Form 3160-5
(June 2019)UNITED STATES
DEPARTMENT OF THE INTERIOR
BUREAU OF LAND MANAGEMENTFORM APPROVED
OMB No. 1004-0137
Expires: October 31, 2021**SUNDRY NOTICES AND REPORTS ON WELLS**
Do not use this form for proposals to drill or to re-enter an
abandoned well. Use Form 3160-3 (APD) for such proposals.

WELL NAME & NO.:	Red Hills 32-5 Fed Com 129H
SURFACE HOLE FOOTAGE:	330'/N & 410'/W
BOTTOM HOLE FOOTAGE:	100'/S & 1100'/W

Cimarex Red Hills 32-5 Fed Com 129H Rev3 kFc 01Sep22 Proposal

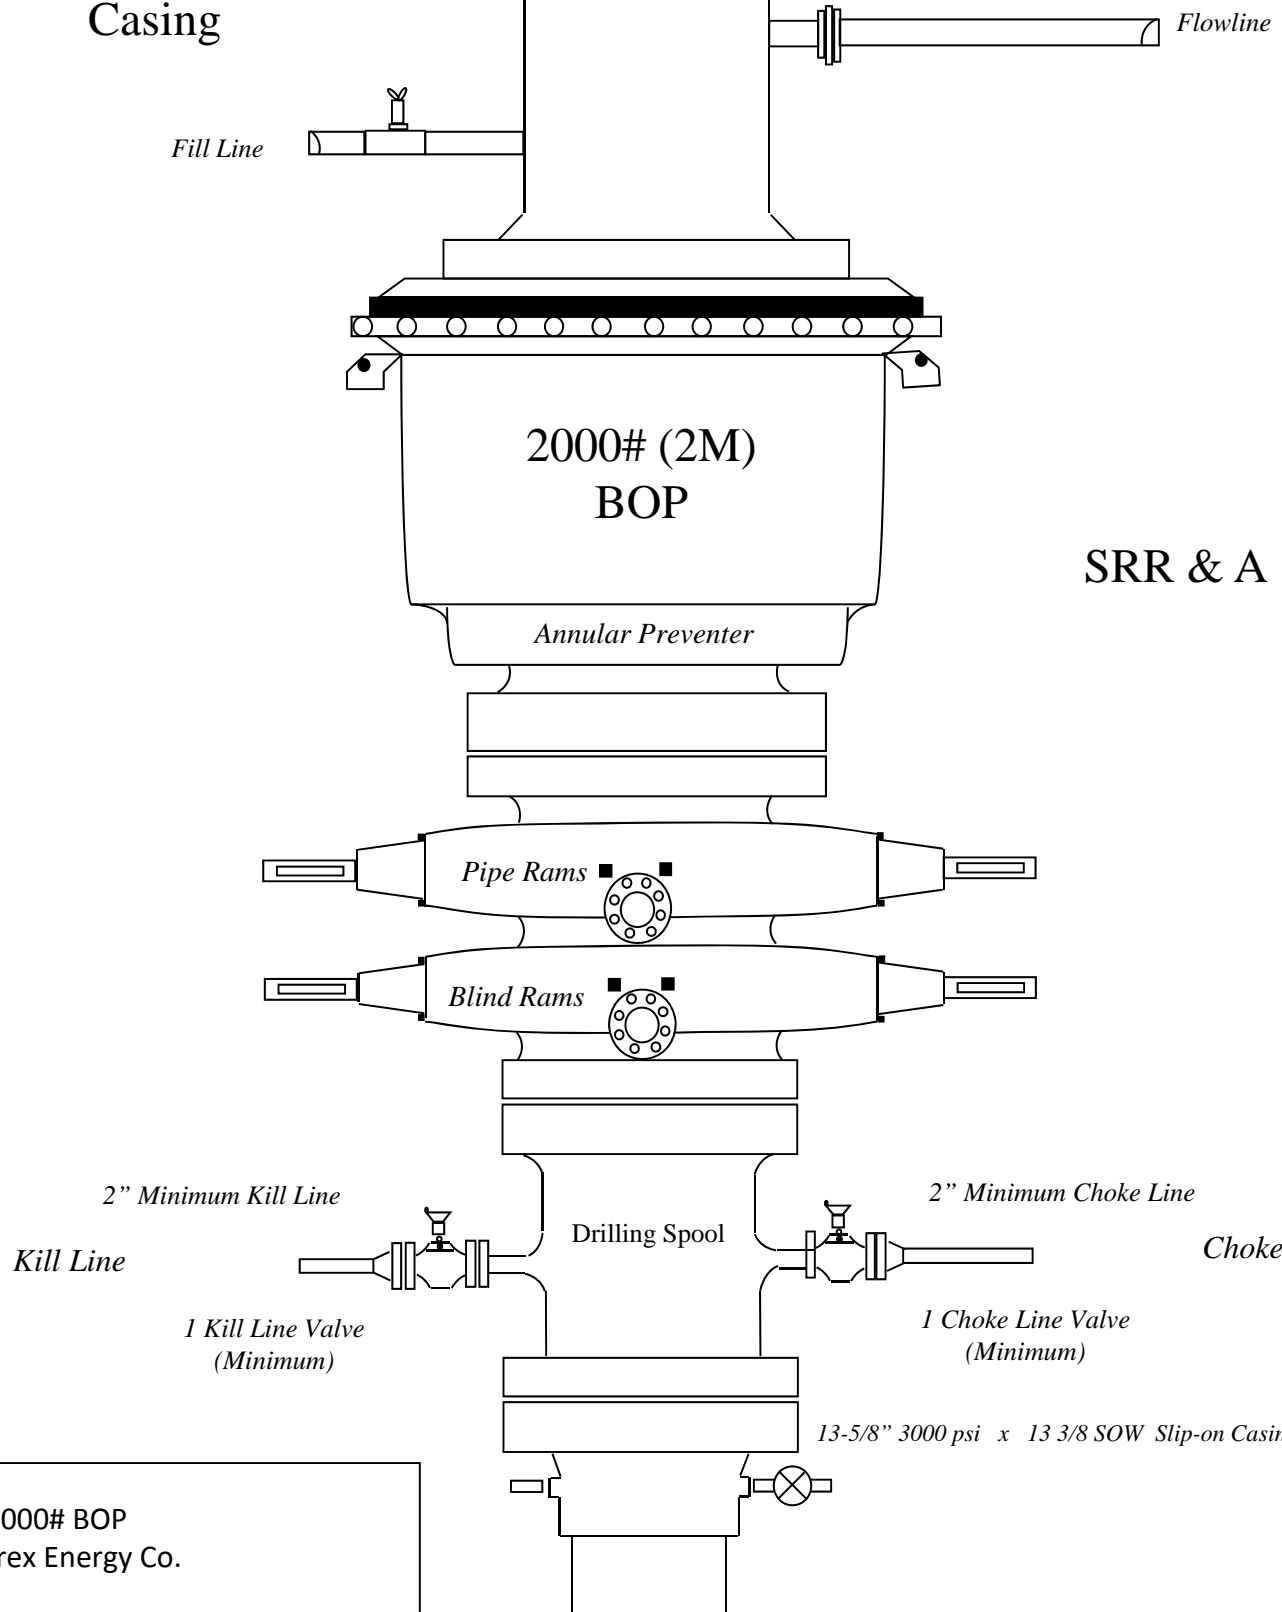
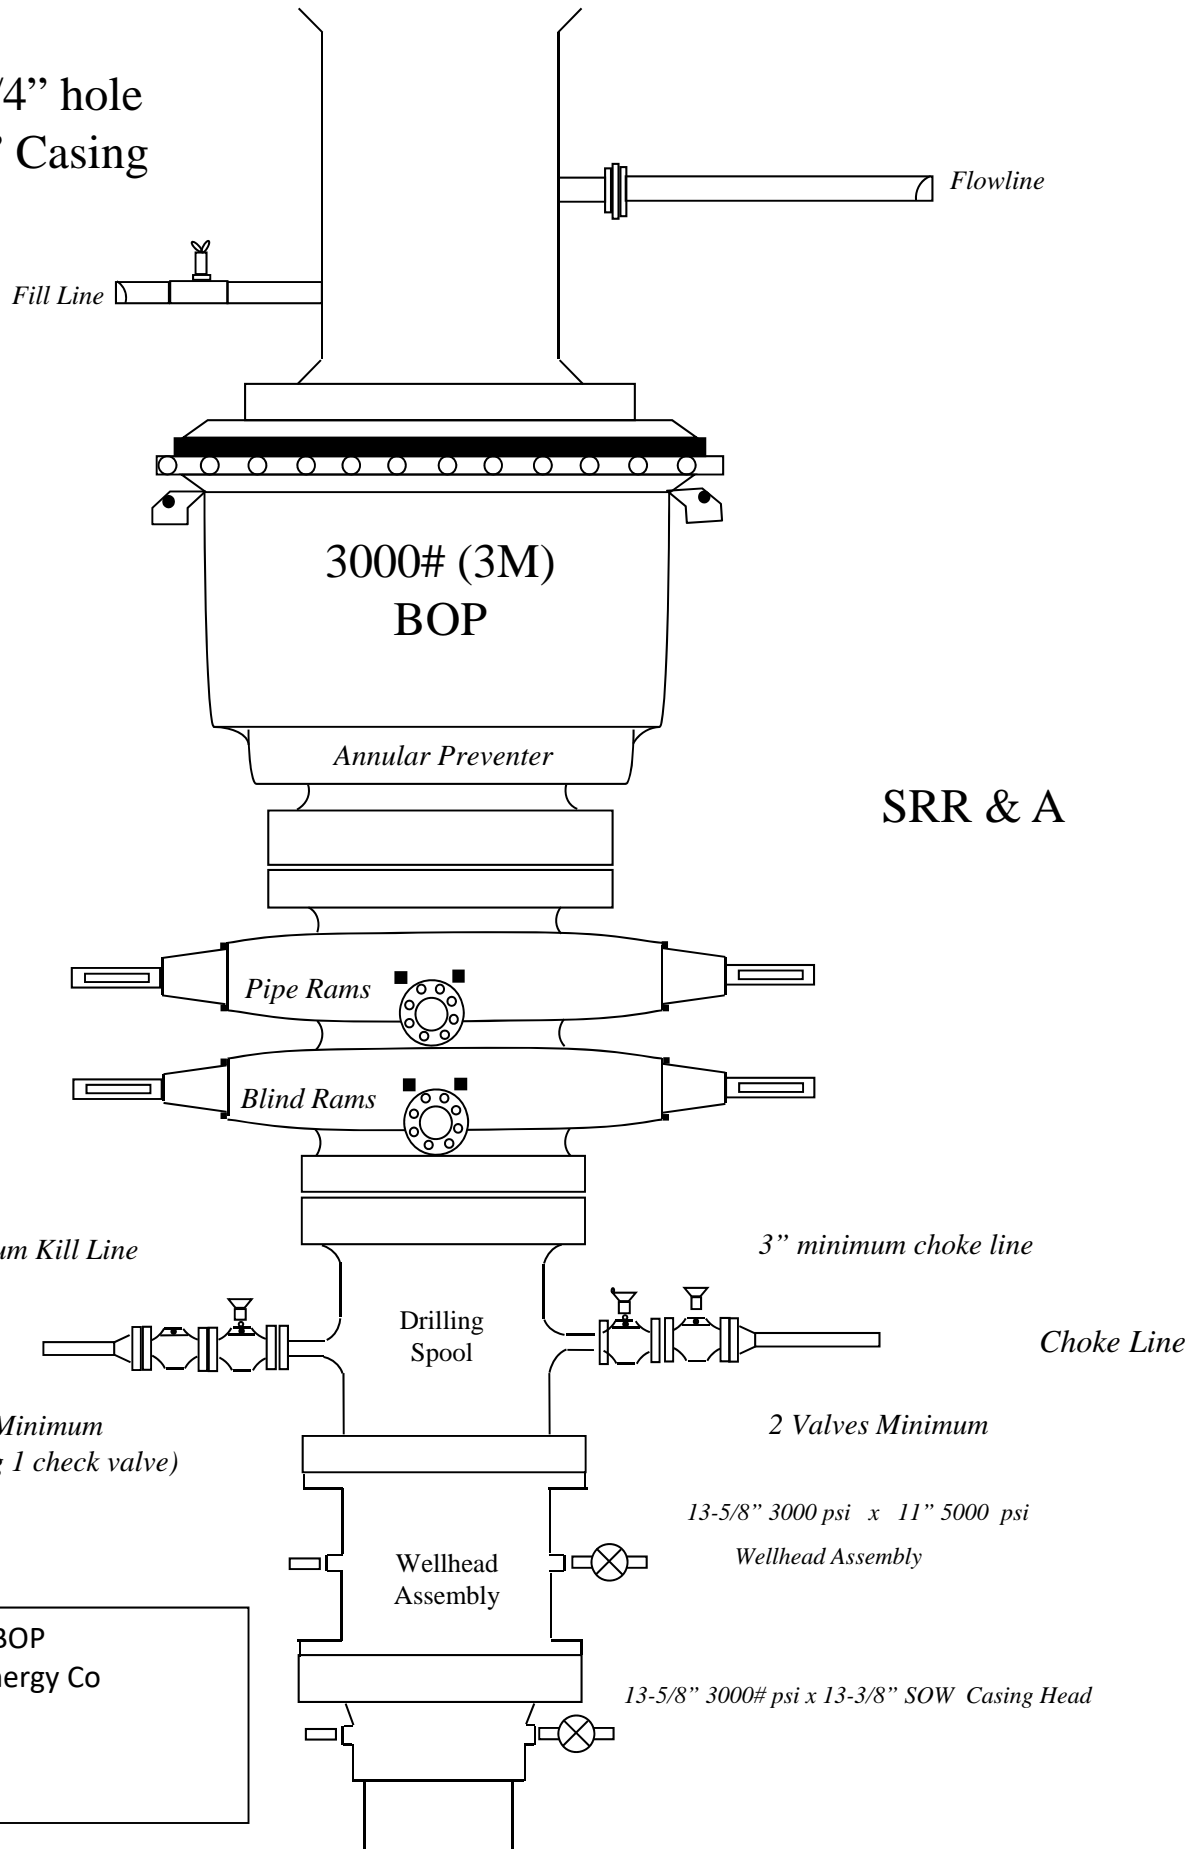
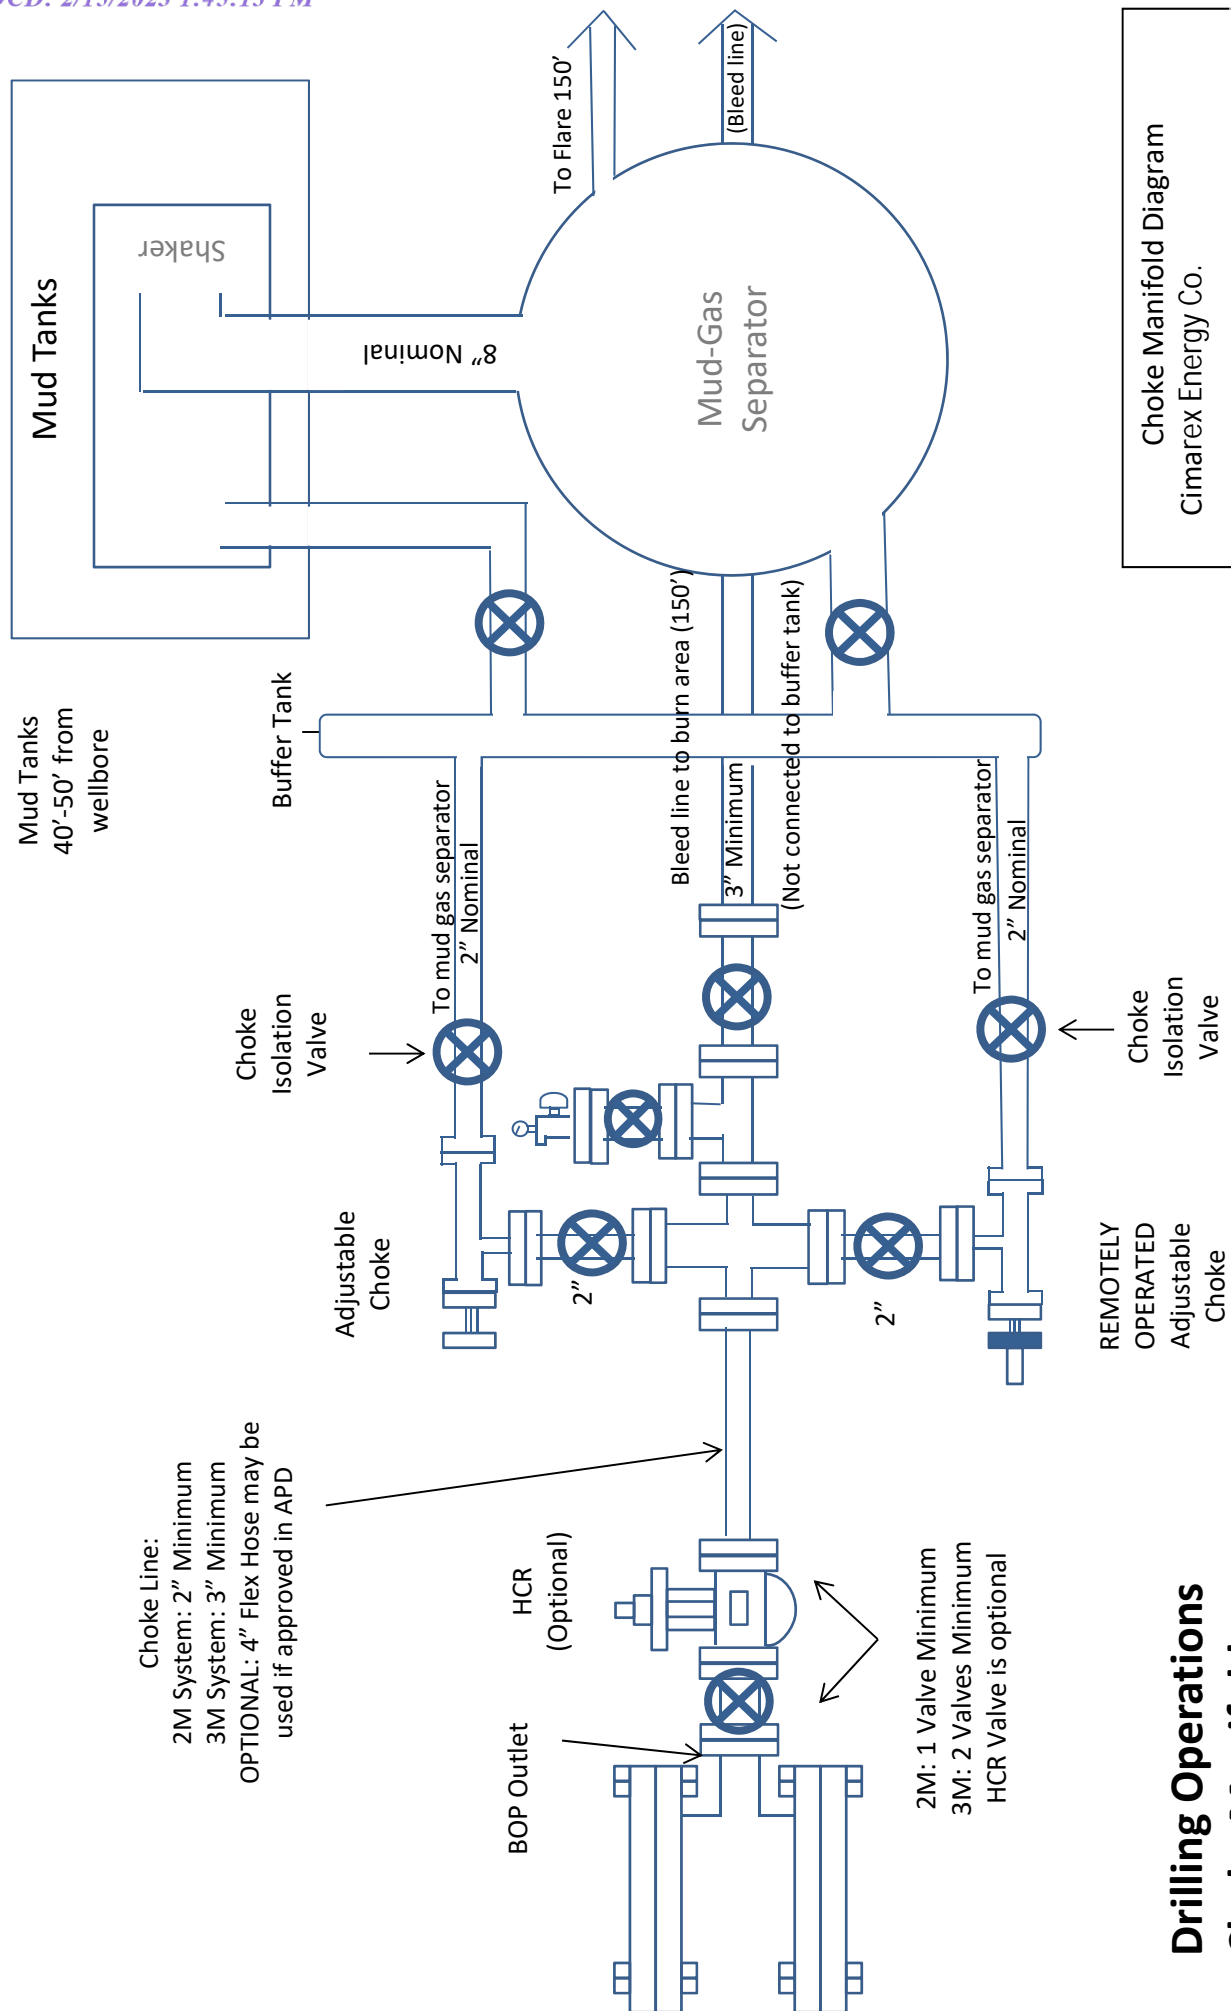
Drill Plan and updated multibowl, BOPs, and choke diagrams are attached.
